## MEMORANDUM – PLAN & DESIGN COMMISSION

**TO:** Plan and Design Commission (“*Commission*”)  
**FROM:** Community Development Department  
**DATE:** for the June 2<sup>nd</sup>, 2026 Commission meeting  
**RE:** **DES-2026-00096, Design Review, Sign Package, and Variations from the City Code (791-799 Central Ave.)**

## **799 Central Narrative for Highland Park Design Review Application | 06.02.26**

# MEMORANDUM – PLAN & DESIGN COMMISSION

OVERALL EXTERIOR ELEVATIONS (NEW)

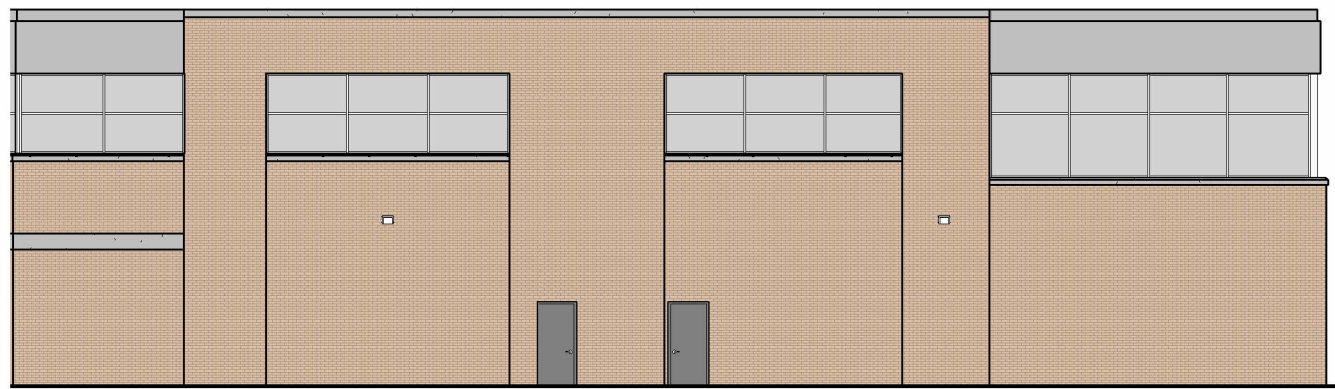
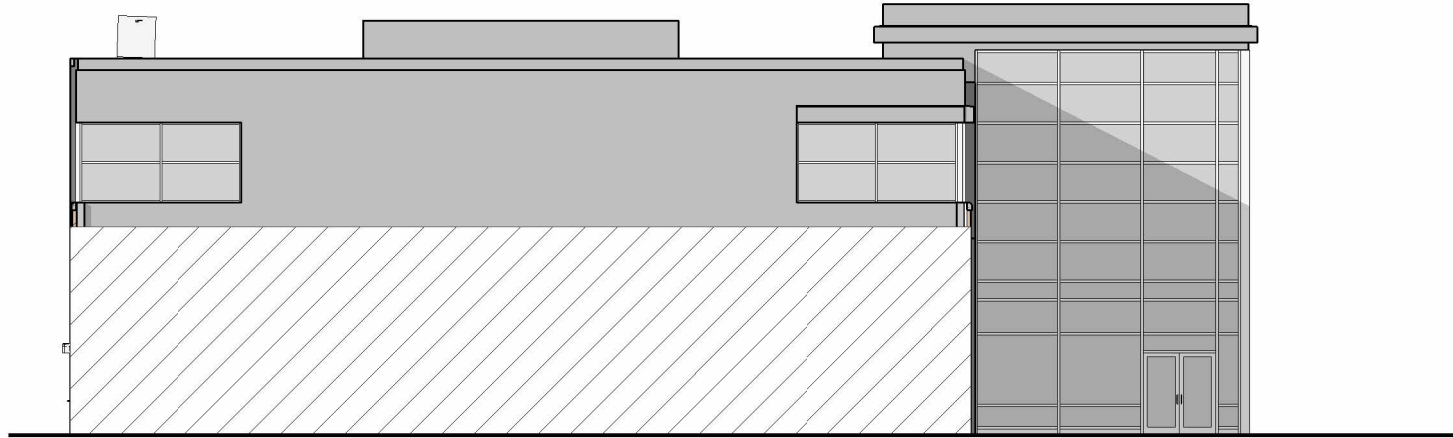
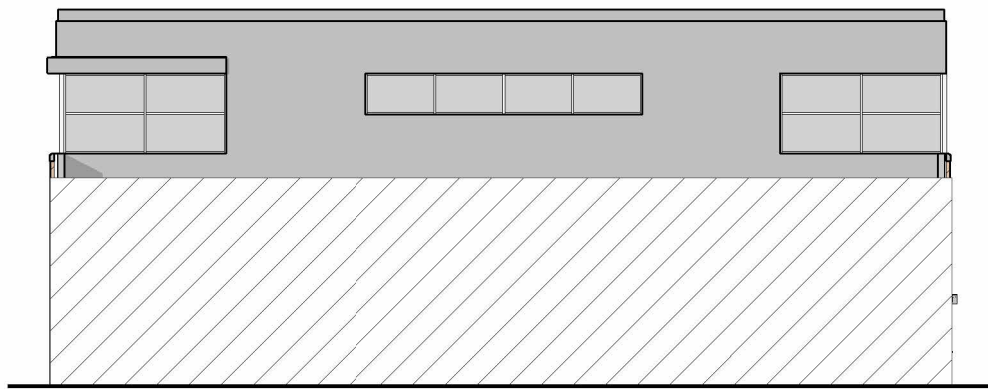
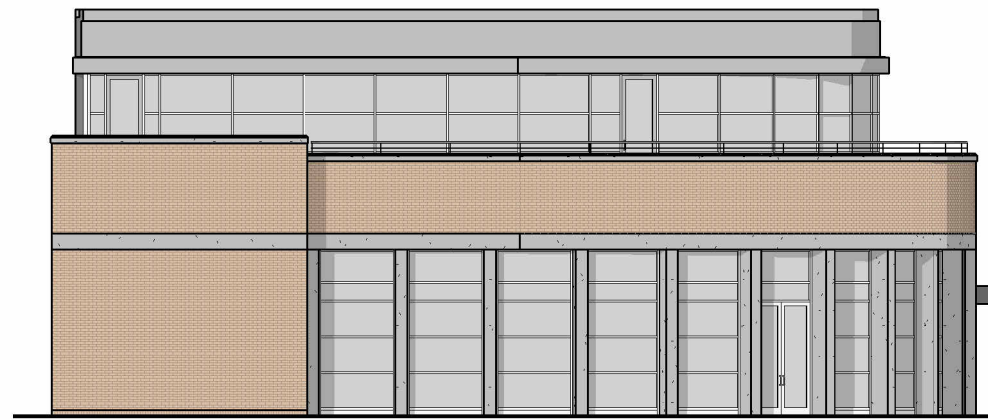
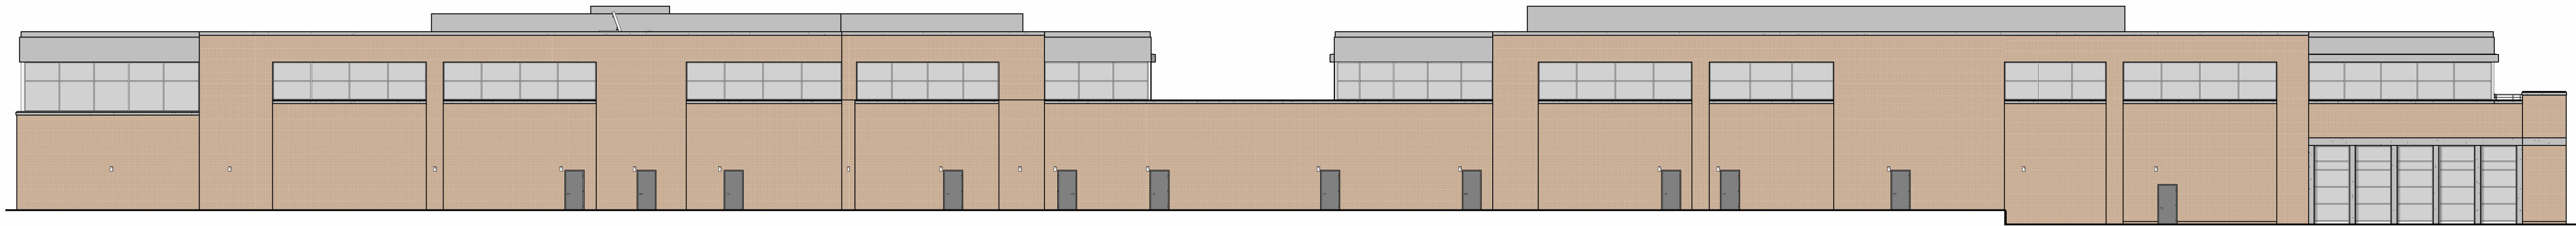
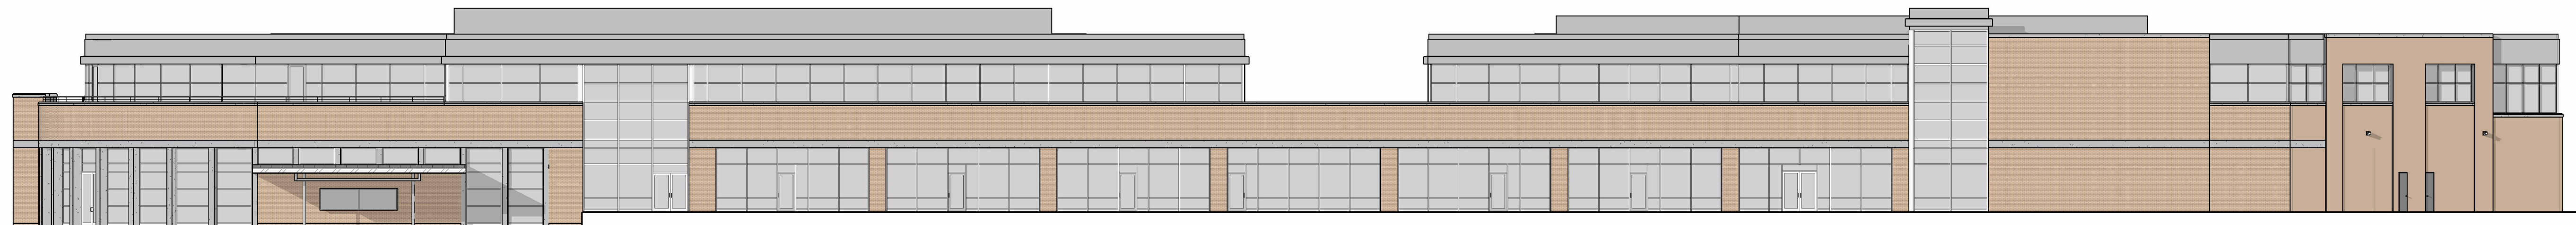
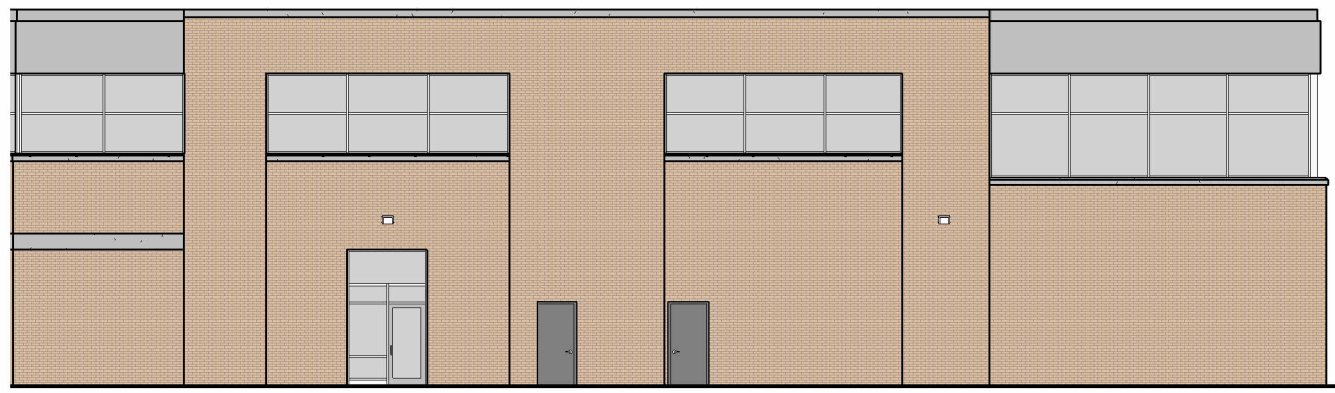
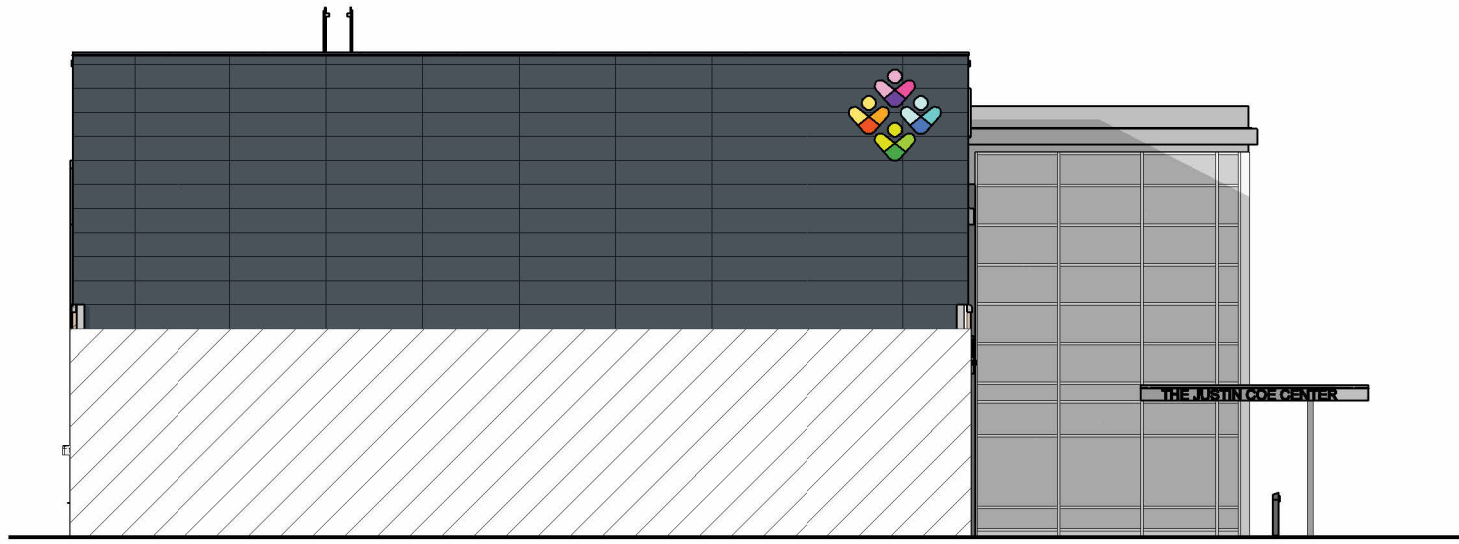
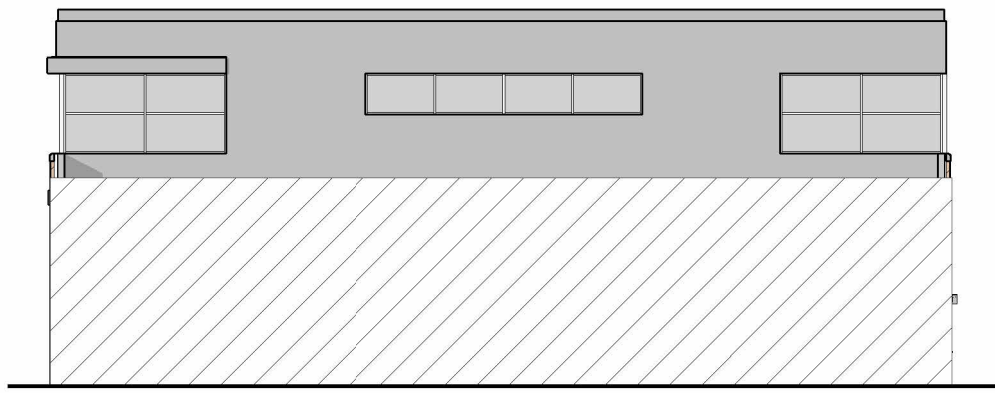
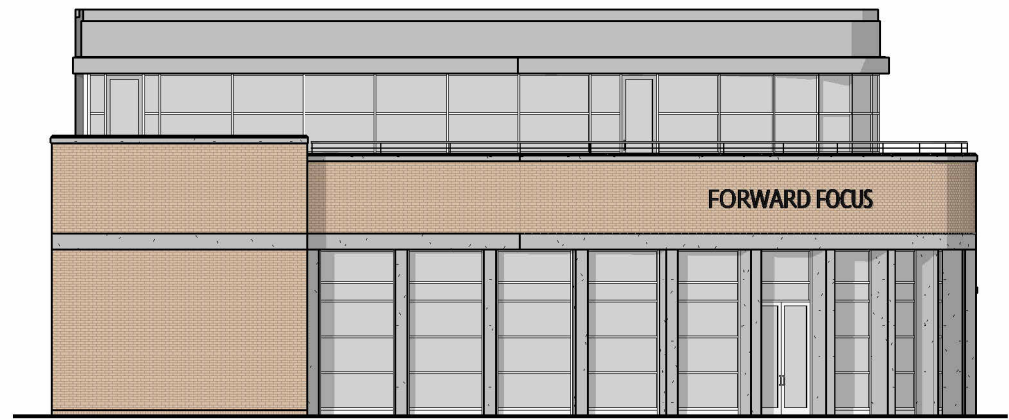
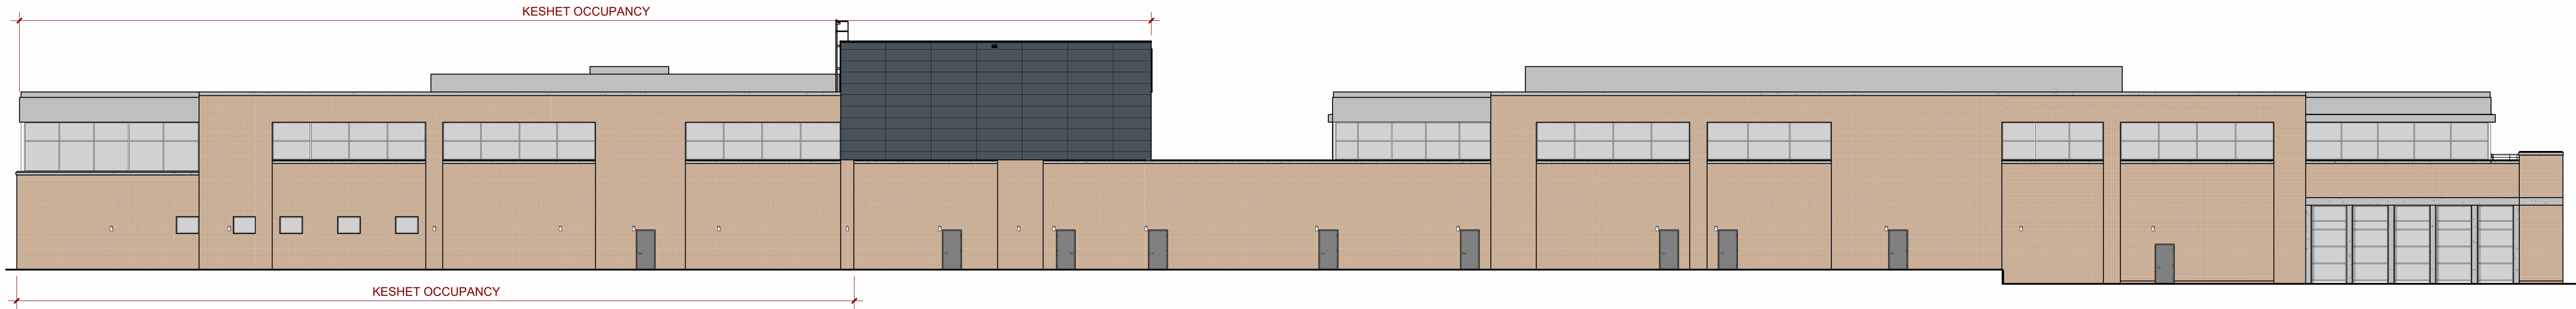
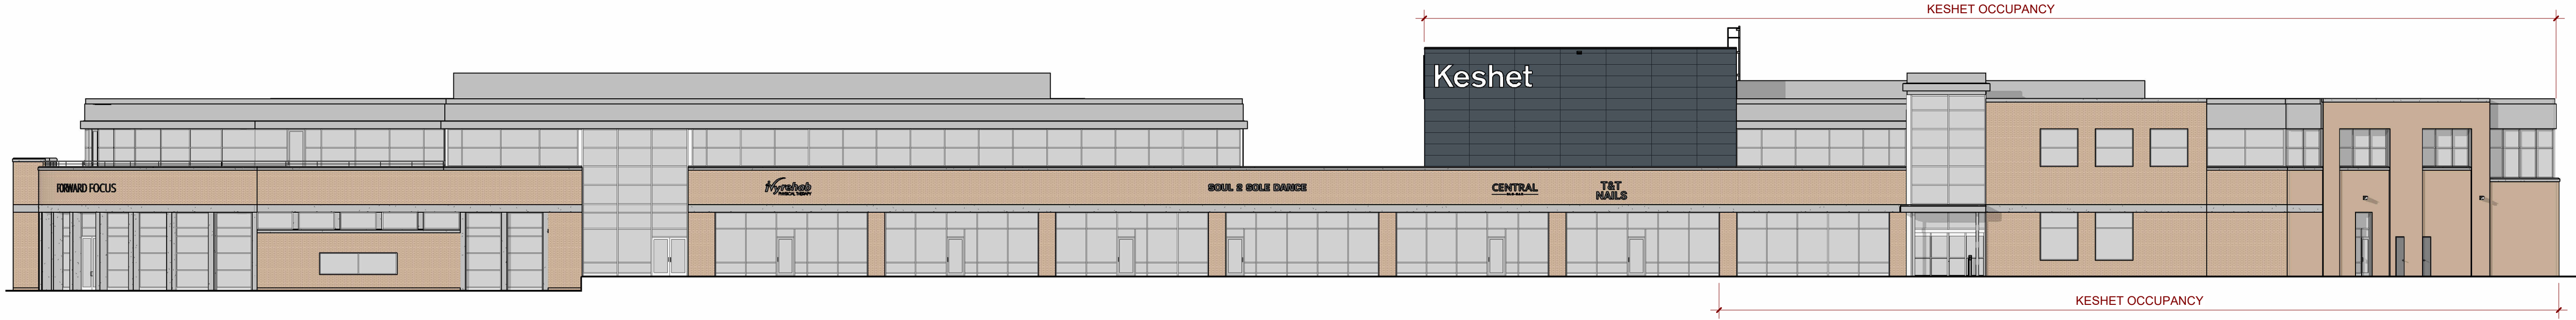
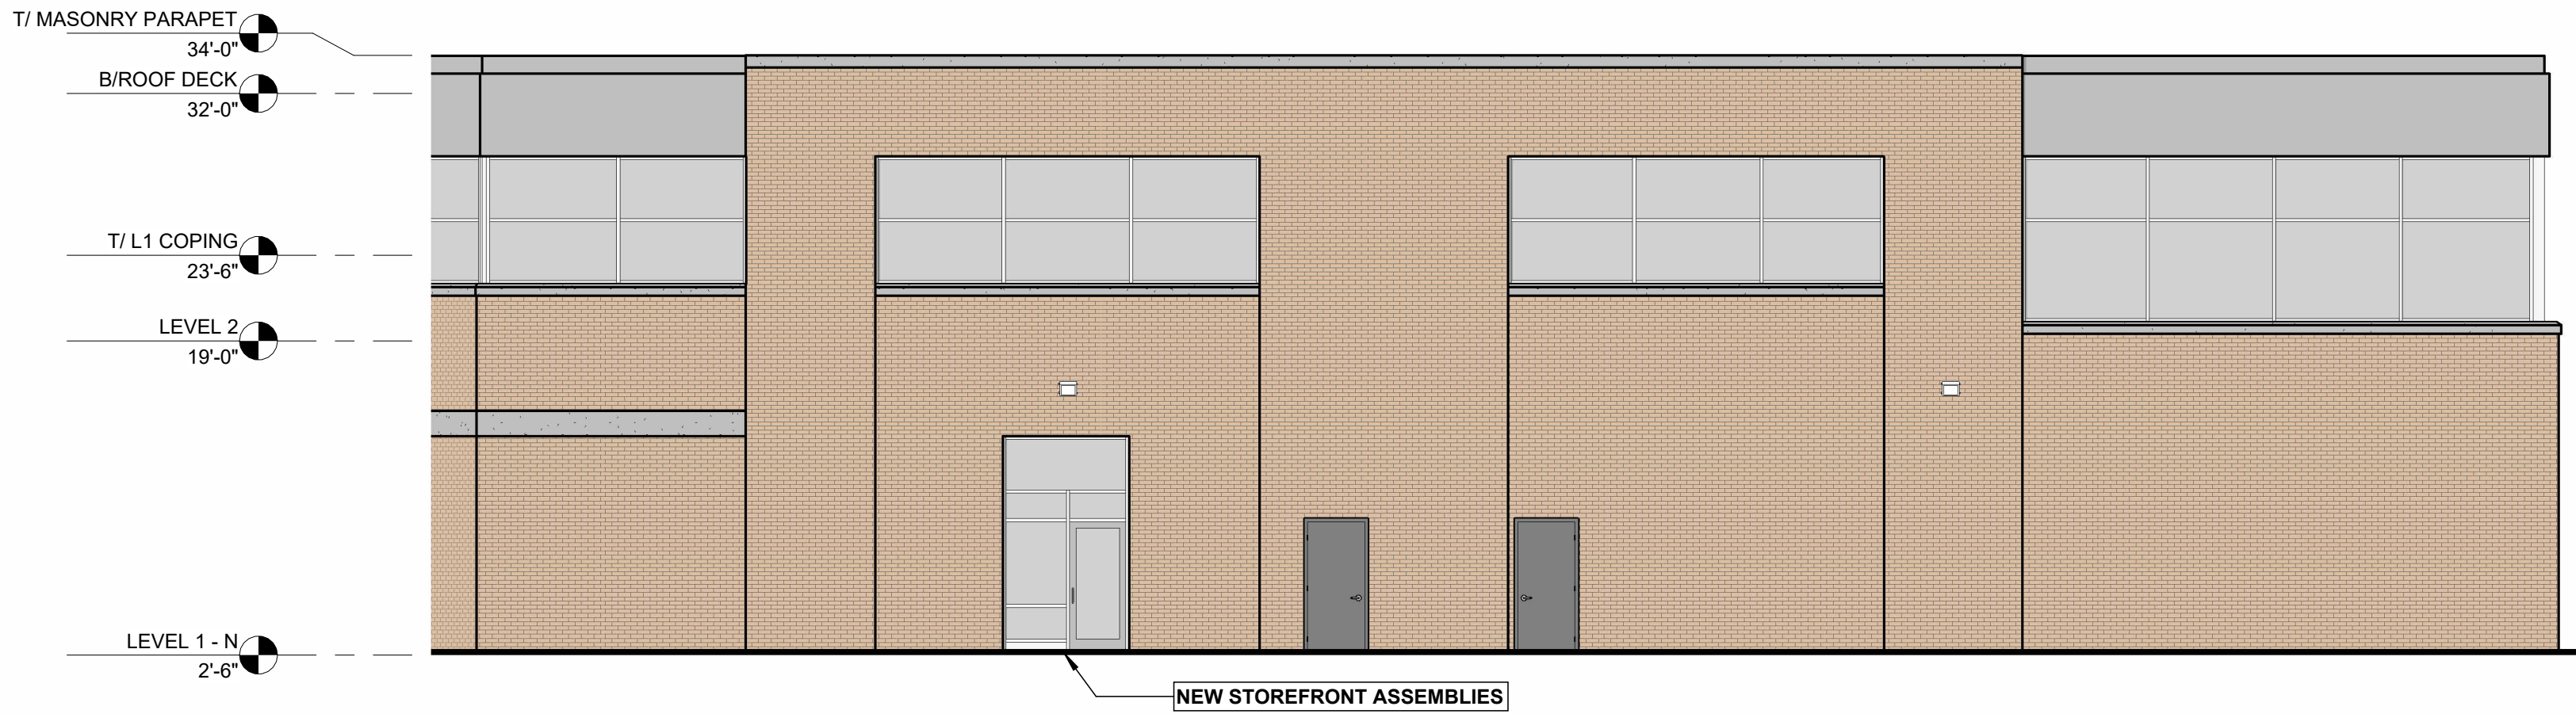
- Change the exterior material and color for the gym addition and monument sign from Copper Patina ACM to Blue Fiber Cement Board.
- A new proposed thermoplastic color design will be installed on the asphalt on the east side of the building, along the internal drive aisle.
- The approved Knee Wall installed around the pedestrian walkway will not be installed.
- Change the dimensions of the previously approved canopy.
- Reduce the amount of openings<sup>1</sup> on the west façade from 6 to 5.
- Reduce the amount of openings on the north façade from 2 to 1.

The Applicant proposed a change in the overall height of the principal structure by 9'. A rendering and elevations have been provided in **Attachment 4**. The overall footprint of the structure did not change, and the majority of the work will take place on the interior of the property.

The maximum allowed height in the B4-5 district for a principal structure is 51 feet. The proposed height after the addition will be 43 feet.

- **Staff Comment:** The proposal **complies** with B4-5 height requirements.
